To: Chair Stanley & Members of the Planning Board
From: Sean King, Urban Designer
Date: October 7, 2022
Re: Lambert Woods Housing Development
Project ID: PL-002078-2022; CU-002083-2022
CBL: 385 A001001
Meeting Date: October 11, 2022

Figure 5: Overall Site Plan

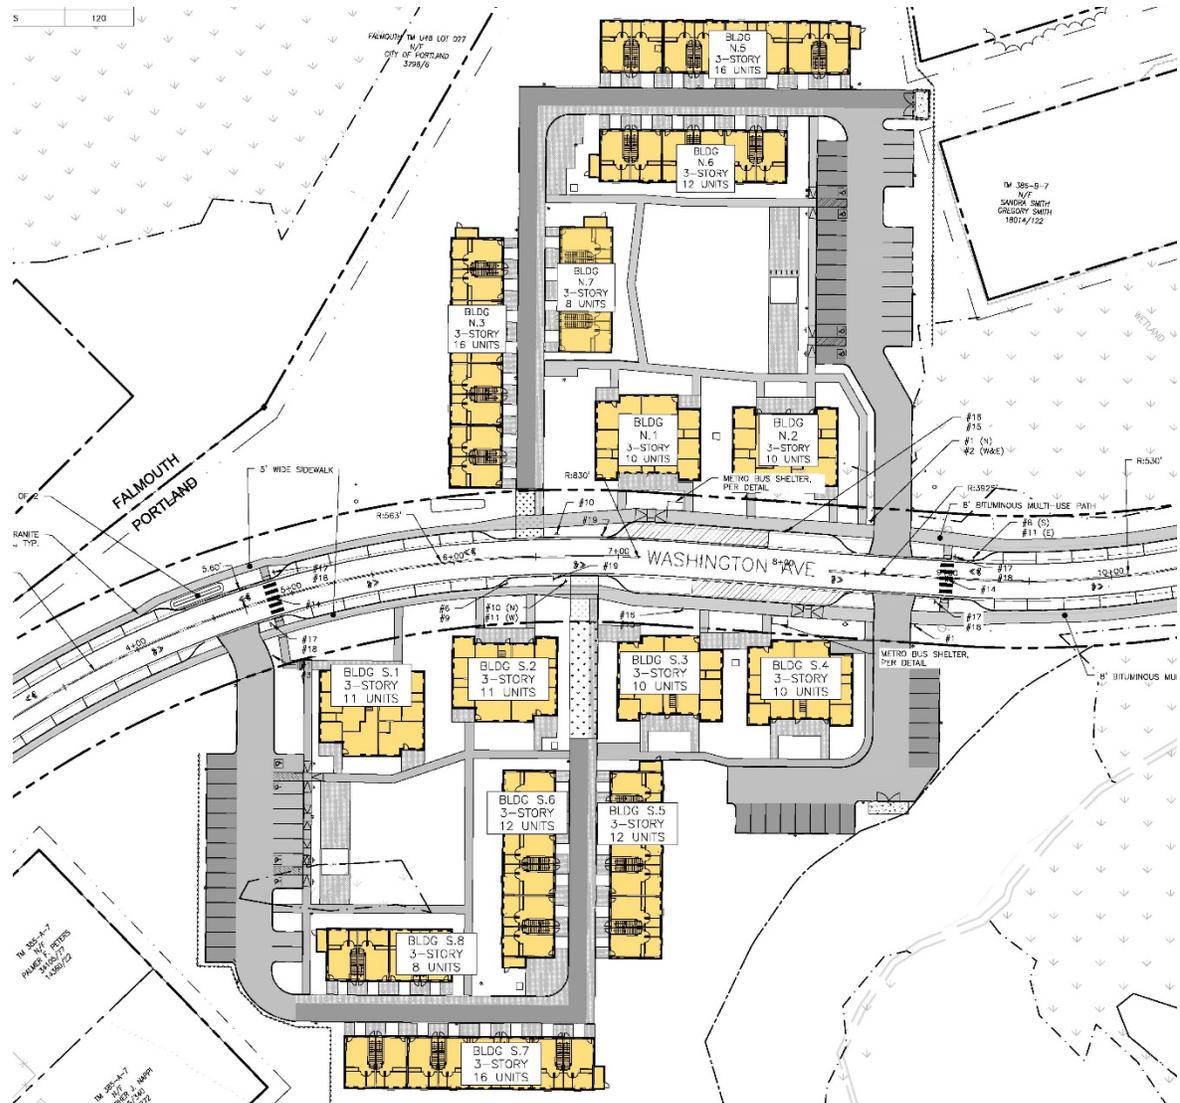
The applicant has requested one waiver relevant to the parking lot and space design:

Technical Manual Section 1.14.3 – Drive Aisle Width

The applicant is requesting to reduce the minimum drive aisle width from the required 24 feet to 22 feet, a two foot reduction.

The applicant has requested one waiver relevant to the amount of driveways allowed:

Technical Manual 1.7.2.8 – Number of driveways

The applicant is requesting to provide (2) driveways at the south site and (1) driveway at the north site. Section 1.7.2.8 of the City’s Technical Manual requires that no more that (2) driveways shall be permitted for ingress and egress purposes to any residential (with 10 or more parking spaces) site.
